Amendment Under 37 C.F.R. § 1.111  
USSN 09/700,258  
Attorney Docket Q61663

**REMARKS**

**APPENDIX**  
**VERSION WITH MARKINGS TO SHOW CHANGES MADE**

FIG. 7

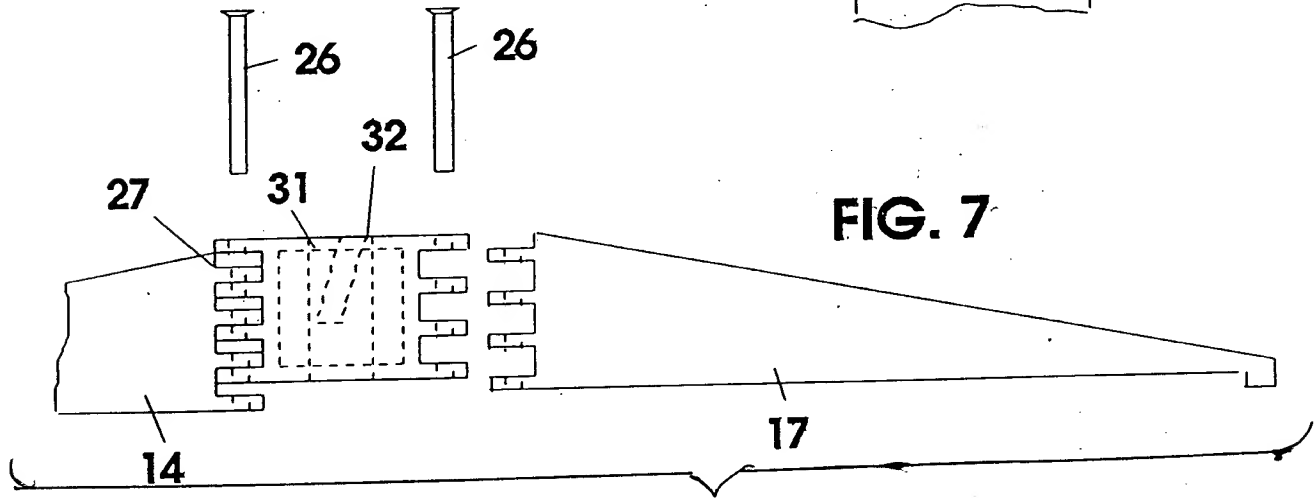
In the last Office Action the Examiner required that the exploded views in figures 14 and 15 required brackets. It is proposed to add brackets to these figures as well as figures 6 and 7 which are also exploded views. Finally it is proposed to add the lead line for the reference numeral 5 in figure 21.

Copies of the sheets of drawings containing figures 6, 7, 14, 15 and 21 are submitted herewith showing proposed changes in red for approval.
